**CITY OF BLOOMINGTON  
PLAN COMMISSION AGENDA  
June 10, 2013 @ 5:30 p.m.**

**BLOOMINGTON PLAN COMMISSION  
STAFF REPORT  
LOCATION: 320 N. Walnut Street**

**CASE#: SP-21-13  
DATE: June 10, 2013**

**BLOOMINGTON PLAN COMMISSION  
STAFF REPORT  
LOCATION: 319 N. Walnut Street**

SP-21-13  
 East and South Elevations

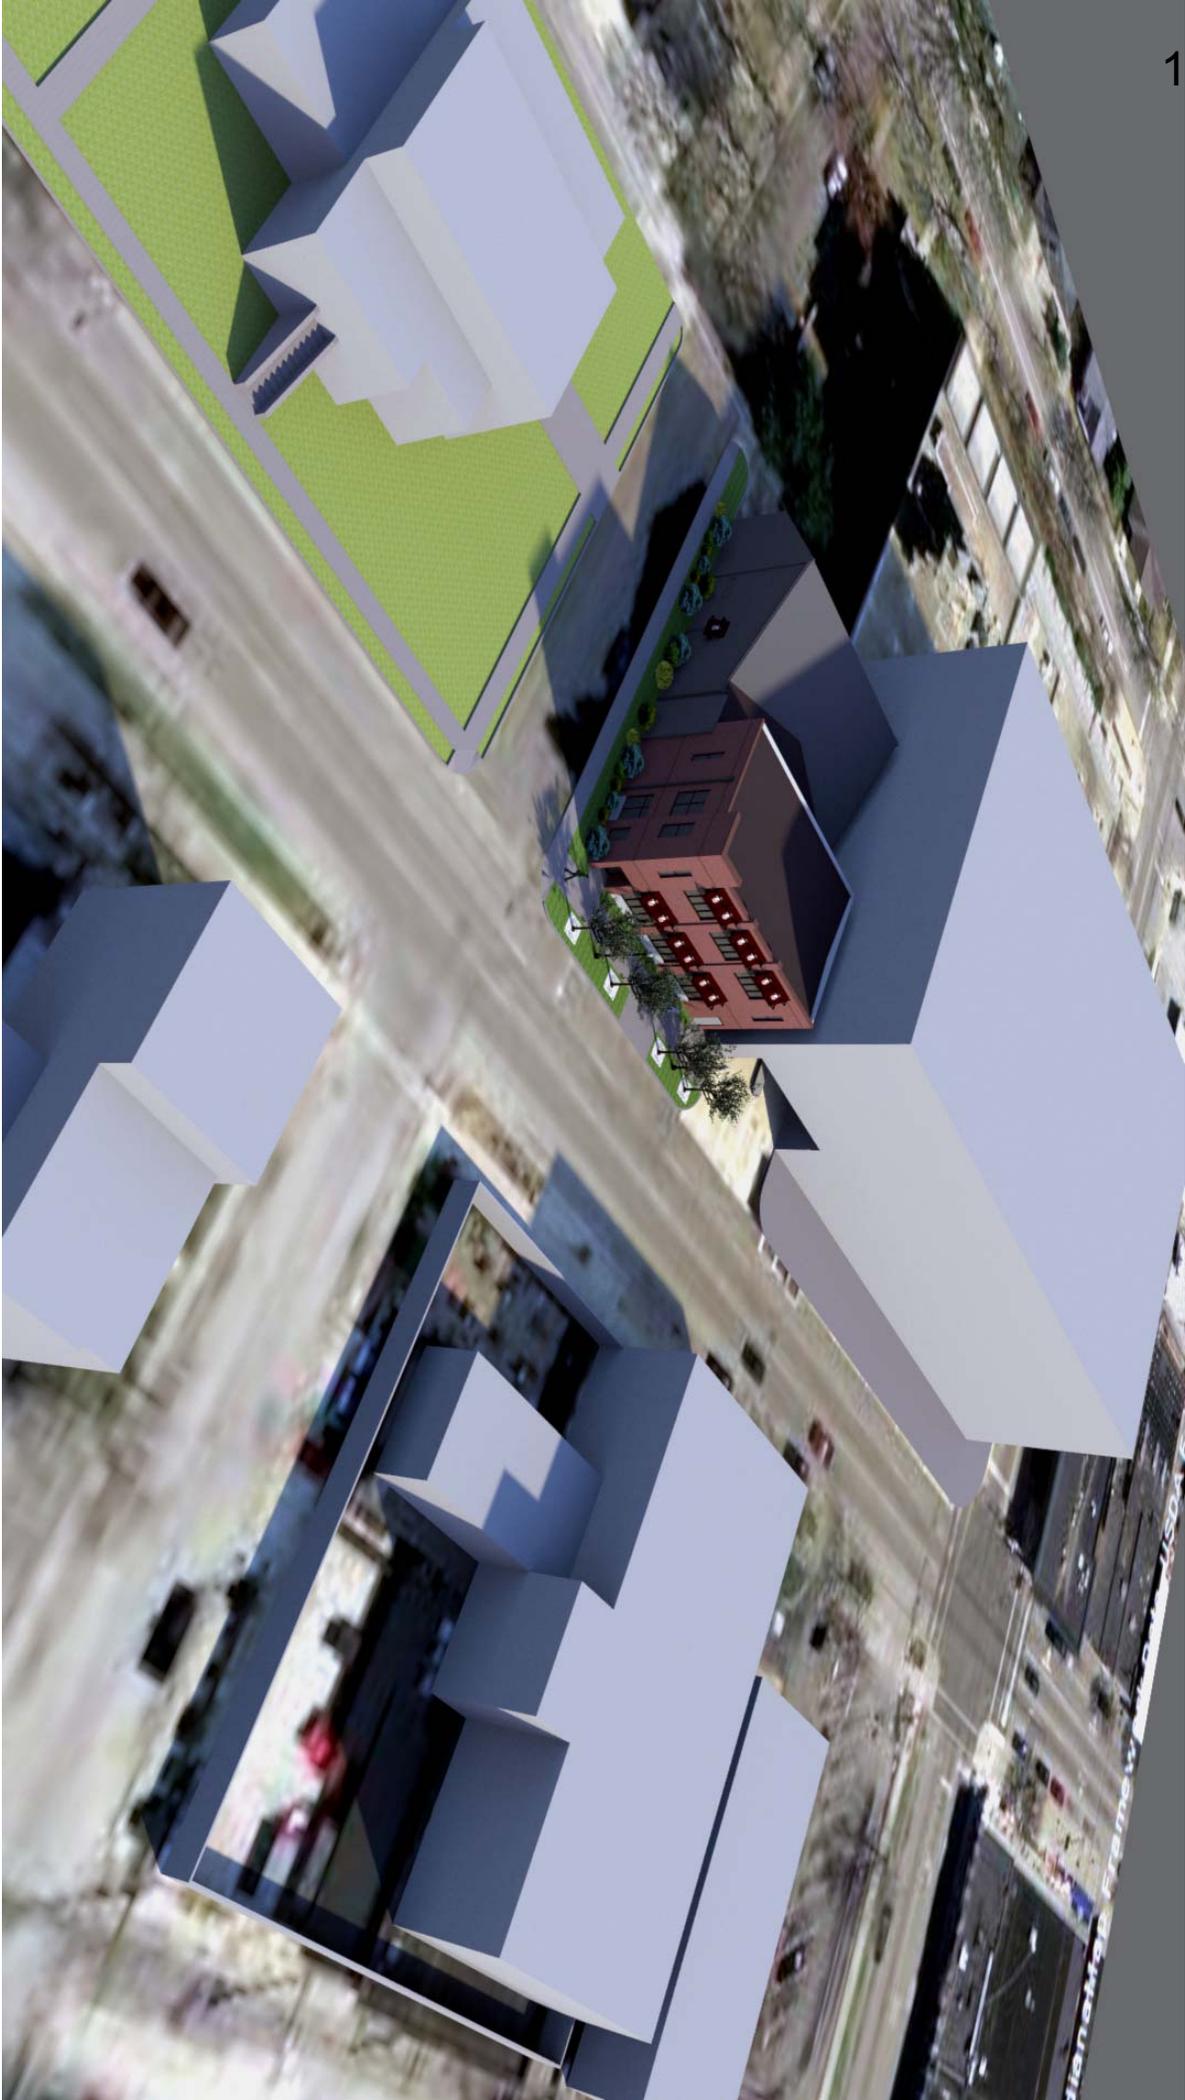
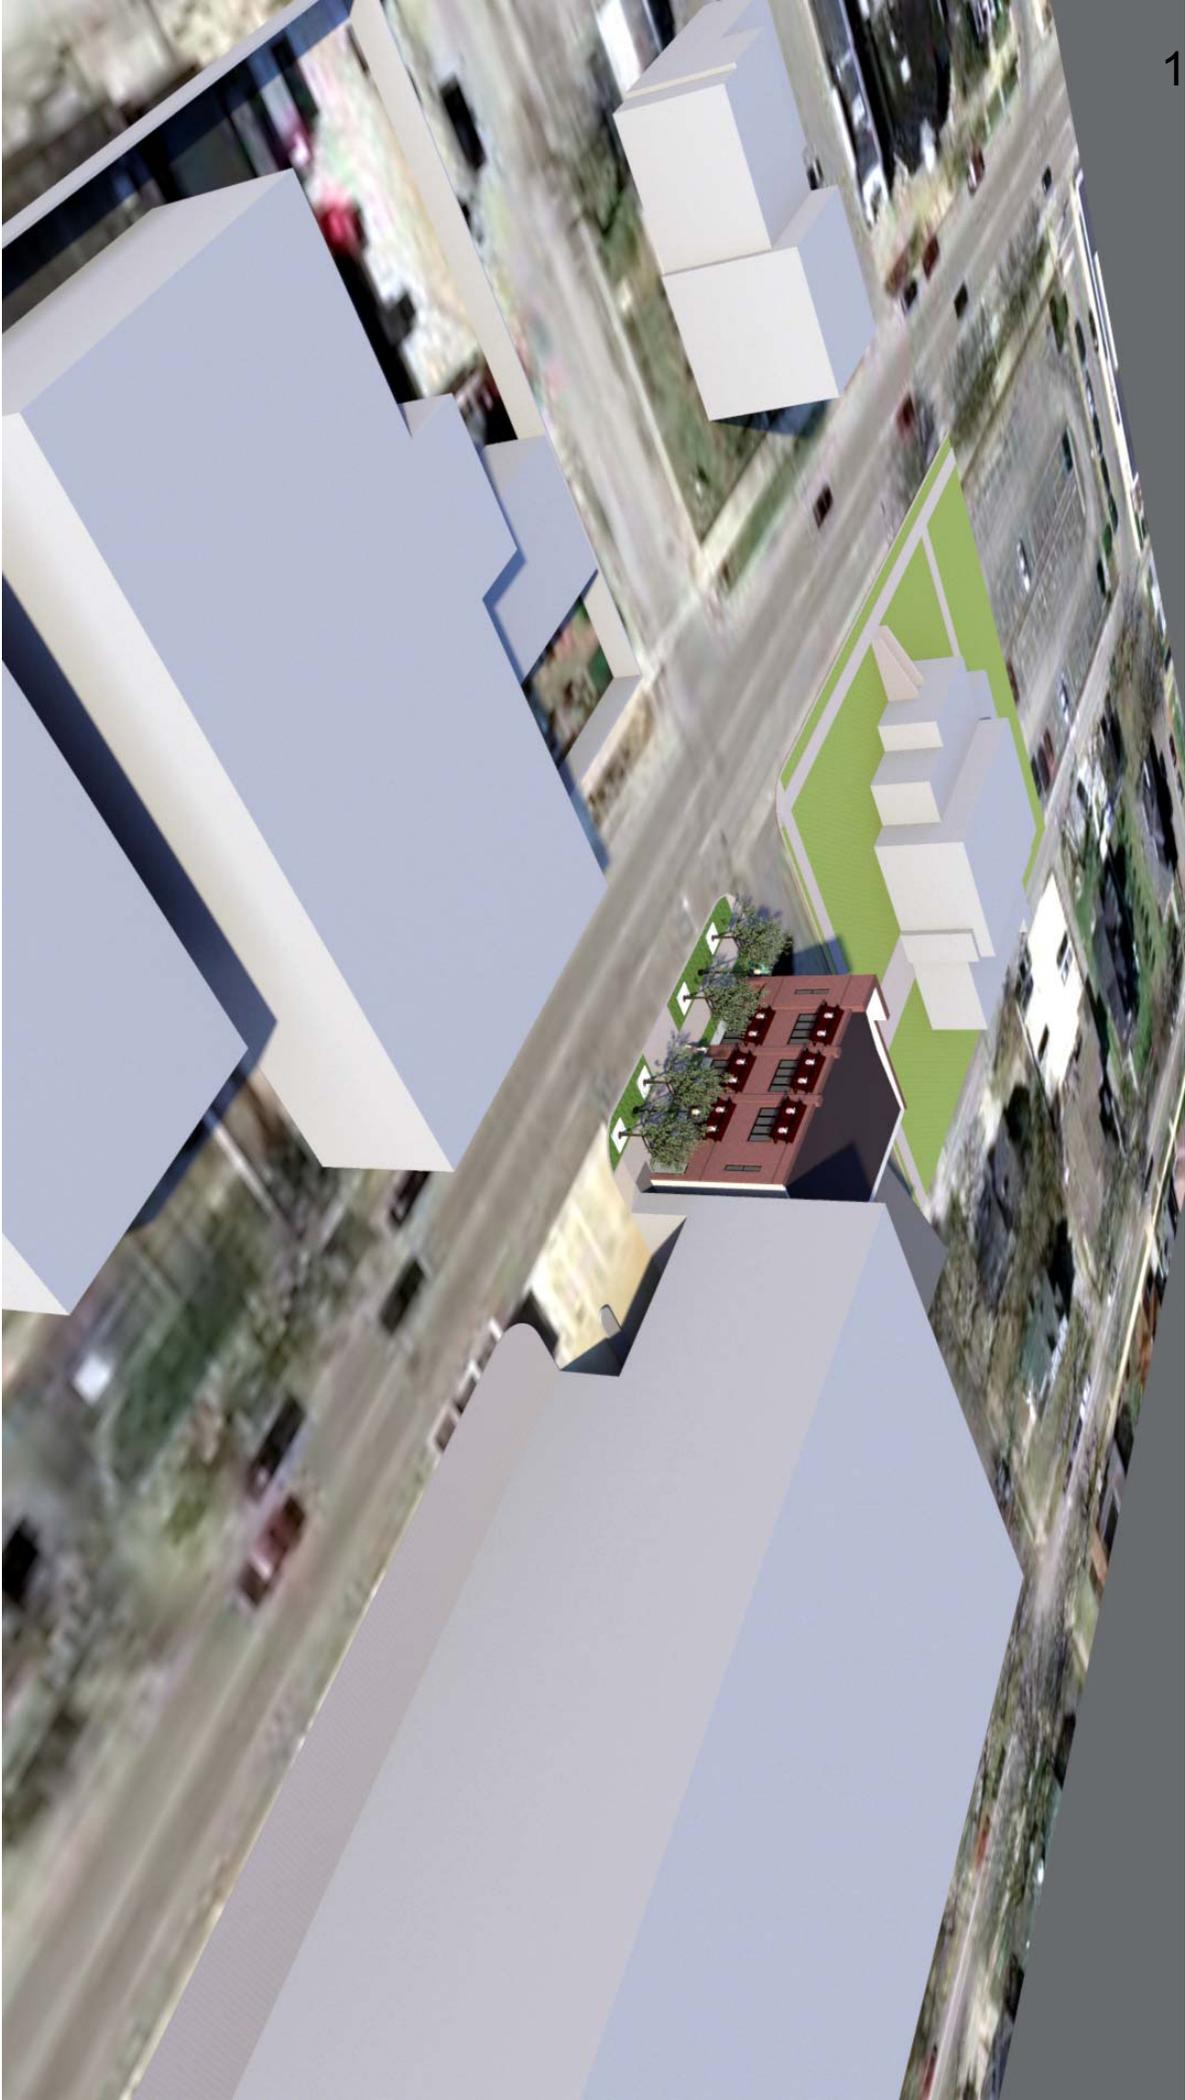
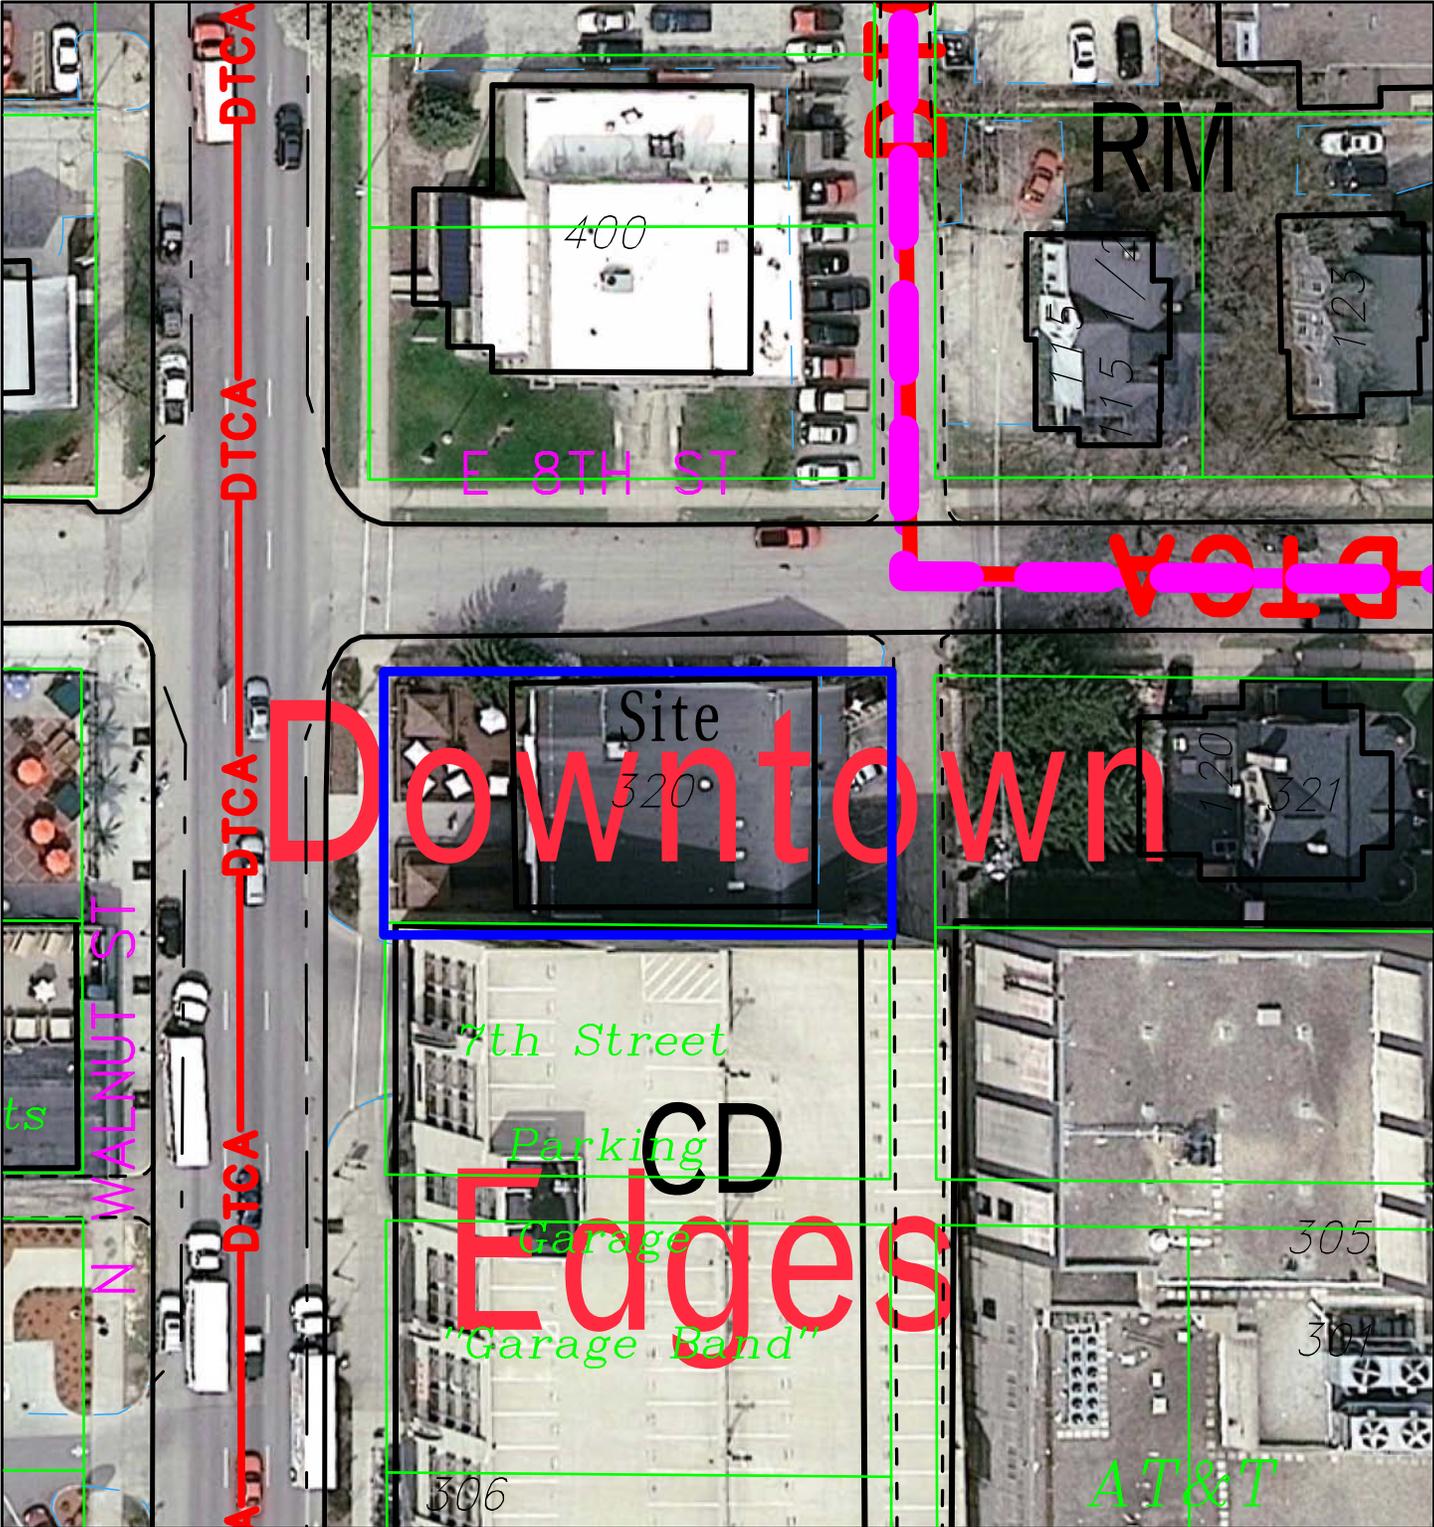
**Architecture:** The new building will have brick veneer along the west facade facing Walnut Street. In addition, the petitioner will be using new brick to cover existing masonry block on the existing building as well as for the new portions of the building facing 8<sup>th</sup> St. The south side of the building facing the parking garage will be finished with cement board siding. A decorative limestone cap has been shown along the top of the building. In addition, a limestone water table will be used along the windows along Walnut and 8<sup>th</sup> Street. Vertical brick columns have also been shown along the front. There are no adjacent historical structures. A pedestrian entrance has been shown along the primary façade along Walnut Street. No mechanical equipment has been shown outside of the building that must be screened. The building has a flat roof which is allowed. The windows and doors along the ground floor meet the 40% void-to-solid requirement for the side of the building facing Walnut St. However the north side of the building facing 8<sup>th</sup> Street, only has 20% void-to-solid and does not meet the void-to-solid ratio. Due to the presence of an internal staircase behind that area the petitioner cannot meet the 40% void-to-solid requirement and is requesting a waiver. The upper floor windows meet the 20% void-to-solid requirements as well. All windows are transparent and do not make use of dark tinting or reflective glass. The primary pedestrian entrance is recessed a minimum of 4' and also has an awning.

**Building Setback Waiver-20.03.260(d)(3):** The UDO requires a 7' sideyard building setback from the property line. The south side of this property would be the only sideyard and is immediately adjacent to a parking garage. The existing building is approximately 3' from the south property line and the petitioner would like to match the existing setback for the addition. No negative impacts have been found from the existing setback and since the adjacent property that would be affected by a reduced setback is already developed with a parking garage, staff finds no negative impacts from this reduction and supports this waiver. The DVISP encourages matching existing setbacks when possible.

**Void-to-Solid Waiver-20.03.270(b)(2)(A):** The UDO requires a 40% void-to-solid ratio along the ground floors facing a street. Since this site is at a corner, there are two facades that would be subject to this requirement. The west side of the building facing Walnut St. meets the minimum 40% void-to-solid ratio. The petitioner is requesting a waiver to allow 20% void-to-solid along the north side facing 8<sup>th</sup> Street instead of the required 40%. The presence of an internal staircase to access the upper floor has made it difficult to meet this requirement. In addition, since this portion of the building faces north and Walnut Street is a one-way street going north, the north side of the building will be less visible from the street. Landscaping will be installed in this area as well to help improve the look of the property and building from the north. Staff does support this waiver. The DVISP places a priority on building design on the most visible portions of the building, which in this case would be the Walnut St. side of the building.

**Building Façade Modulation-20.03.270(c)(1):** The UDO requires a building façade module that is offset by a minimum depth of 3% of the total façade length every 45'. The building is 60' long along Walnut St. and would be required to contain a module that is at least 1.8' in depth. No module is required along the north side of the proposed building facing 8<sup>th</sup> Street since this area is less than 45' long. Due to the limited amount of space between the existing building and the front property line, the petitioner is requesting a waiver to not require the modules. The standard module described in the DVISP is 65' in length, which is less than the length of building frontage along Walnut St. or 8<sup>th</sup> St.

The EC recommends that the Petitioner take advantage of a wide tree plot for vegetation, use green building design, and change the architecture such that the new structure won't look so awkward combining two completely differing architecture styles into one building.

**SP-27-13  
 Site Plan**

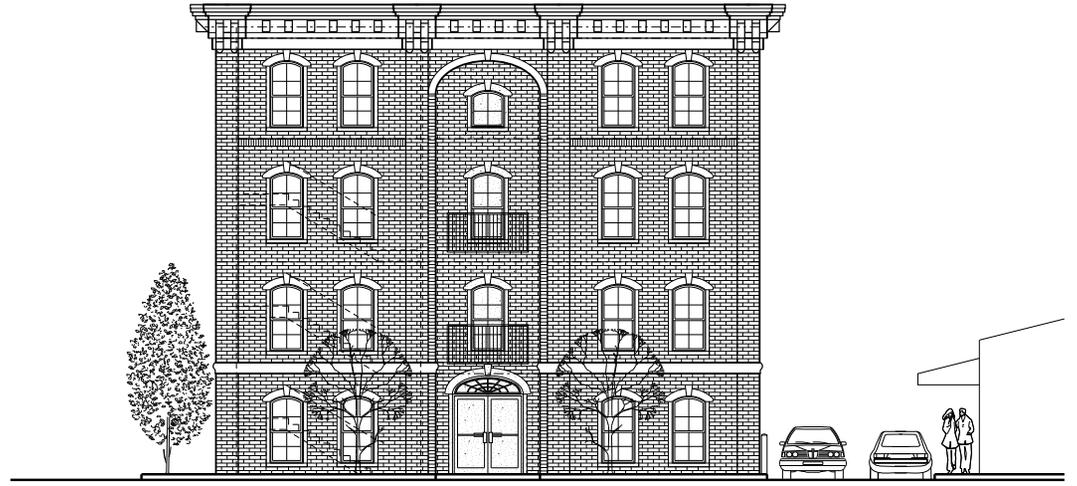
**Setbacks:** The DCO does not require any setback for structures on this property. The proposed structure will be placed at the south property line. There is a small overhang for the cornice of the building. The petitioner must either receive an easement for the air encroachment or set the structure back enough to remove the encroachment. Although the petitioner is proposing windows on the southern wall, these windows are not required for ingress/egress due to the fire suppression system to be installed in the structure. Construction in the future could block these windows in the future.

The structure is also set back from the northern property line enough to create a widened alley to allow access and to accommodate an existing sidewalk and building encroachment along the property to the north. This setback will also allow for adequate separation from an existing utility line.

**Streetscape:** The petitioner is proposing to create a new streetscape that would include a tree plot with two street trees and a 5-foot wide sidewalk. There is a very large right-of-way at this location which the petitioner will be seeking to utilize for bicycle parking and installation of the required fire meter pit and Fire Department connections. These will require an encroachment approval. This proposal requires a waiver from the requirement to place street trees within 5' x 5' tree grates.

**Tree Grate Waiver-20.03.130(a)(4):** The Downtown Vision and Infill Strategy Plan (DVISP) state that street trees are considered an important component to any downtown development proposal. It recommends tree grates to be utilized when appropriate. Staff finds that due to the very wide right-of-way and the residential nature of the proposed structure make a more appropriate streetscape. This proposal would remove a parking encroachment into the right-of-way and would be consistent with the tree plot located on the property to the south, allowing for a more consistent pedestrian path along S. Washington St. Staff supports this waiver.

4. The south side of the structure must also include "bricked-in" windows as shown on the north side of the first floor of the structure.
5. The petitioner must receive an easement from the property to the south to allow for the cornice encroachment to the south or the building must be setback to the north enough to remove the encroachment.

SP-27-13  
Elevations

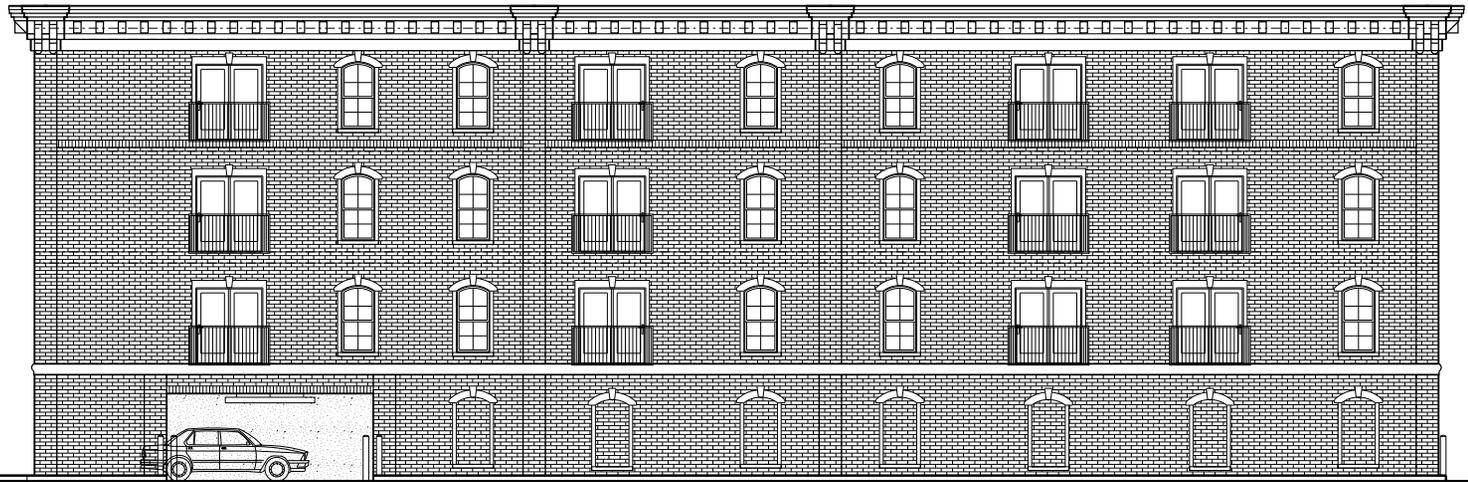
**Windows:** The structure has shown a large number of windows on all facades. The windows that are on the south side of the structure are located at the property line and may be covered by future construction of that property. Due to this structure including appropriate fire suppression, these are not required ingress/egress windows. The petitioner has also added "bricked-in" window details to the north and south side elevations to reduce the impact of blank wall associated with the garage portion of the structure.

**Materials:** The structure will be constructed of primarily brick and limestone. The petitioner has proposed a large cornice for this structure to create a pronounced building cap with significant detail. Originally the petitioner had proposed to construct this of EIFS. However, the petitioner has agreed to construct this cornice with alternative materials including options such as fiberglass and metal. These materials are permitted and do not require a waiver.
